## SERVICE BULLETIN

Document No. 159-012-00, Rev. 0

**Subject:** Cargo Hook enhanced safety.

**Helicopters Affected:** Robinson R22 and R44 aircraft with 12 volt electrical systems and an Onboard Systems 3.5K Keeperless Hook, part number 528-023-00, installed.

Step 6  
Place end of new spring around cam as shown.

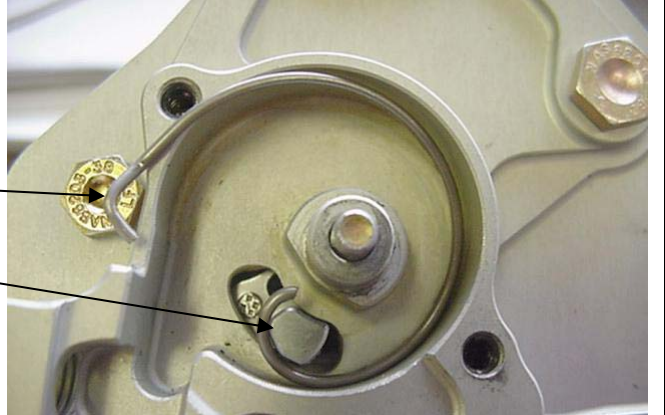
Spring  
Cam

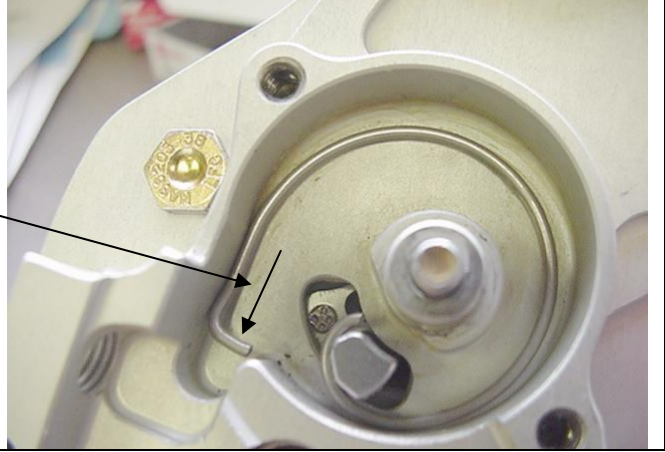
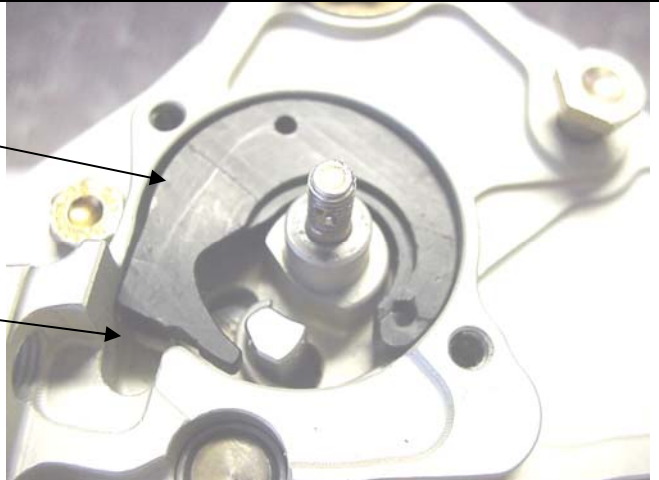
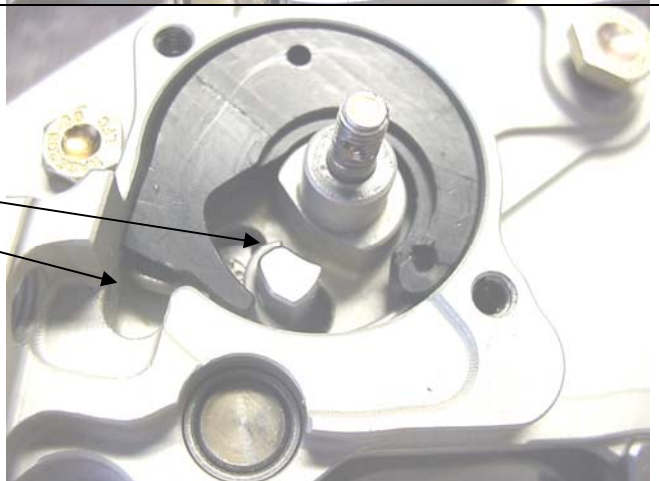
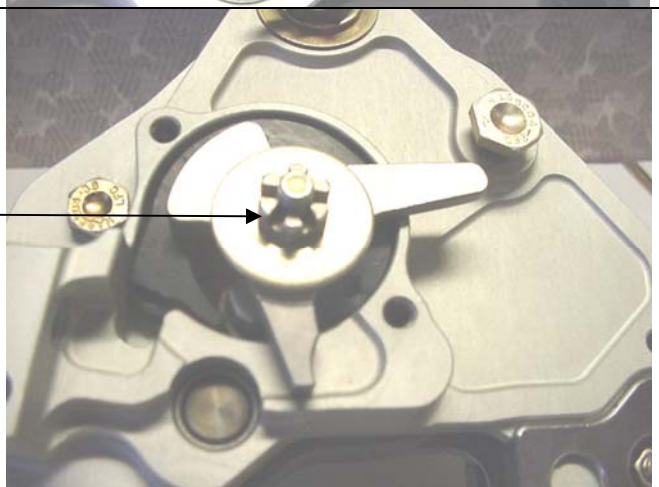
Step 7  
Apply gentle pressure as shown to insert spring into pocket.

Step 8  
After insertion the spring assembly should retain itself in a position as shown at right.

Step 9  
Pre-load spring assembly by pulling end down within the spring cavity.

| <p>Step 10</p> <p>Place spring retainer over spring.</p> <p>If spring retainer does not lay flat, verify that the spring leg has been pulled down far enough. End of spring should be visible below retainer.</p> |    |

Step 13

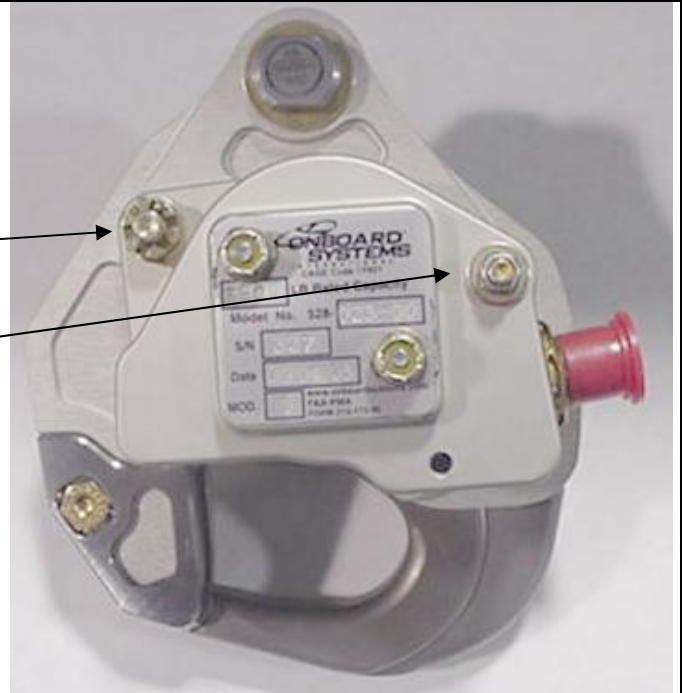
Fasten solenoid assembly onto side plate with washers, nut, and cotter pin.

Torque first nut to 15 in-lbs. and rotate to next castellation to insert cotter pin.

Torque second nut to 20-25 in-lbs.

Step 14

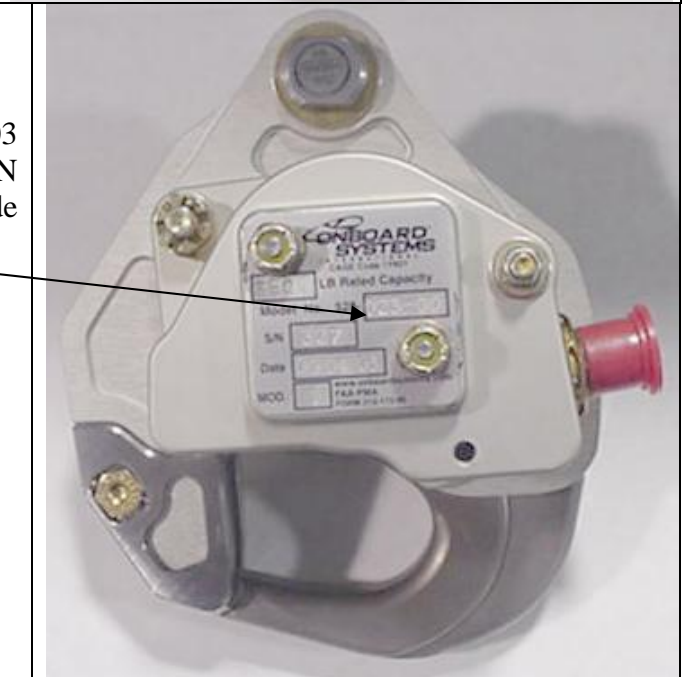
Re-identify the cargo hook as P/N 528-023-03 by steel stamping a “3” over the last 0 in the P/N on the identification plate located on the outside of the solenoid assembly.

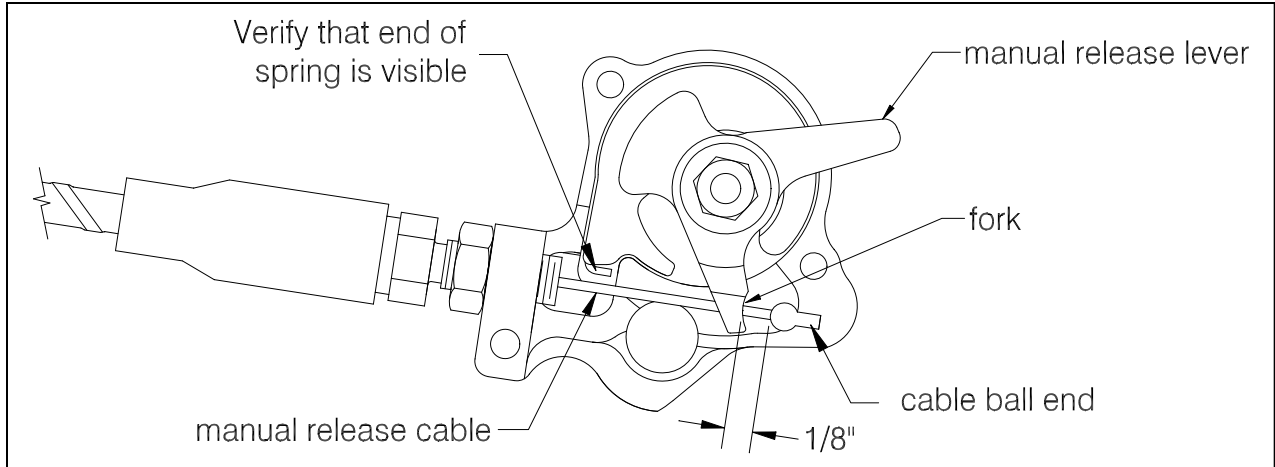
Place the cable into the fork on the manual release lever as illustrated. Verify correct setting per the following. Move the manual release lever in the clockwise direction until free play is removed. Measure the cable ball end free play with the manual release handle in the cockpit in the non-release position. The gap should measure approximately 1/8".
